**SERVICE LETTER: #60**

TITLE: Installation of Pressure Switch Diode.

EFFECTIVITY-FLOAT S/N's: 3730 Amphibious Float Installation

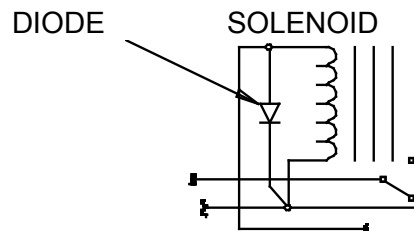
There is an illustration error in the electrical schematics, for the Installation of the diode, for the hydraulic pressure switch.

METHOD OF COMPLIANCE: Ref: electrical schematics in your parts and service manuals, correct the diode installation as shown.
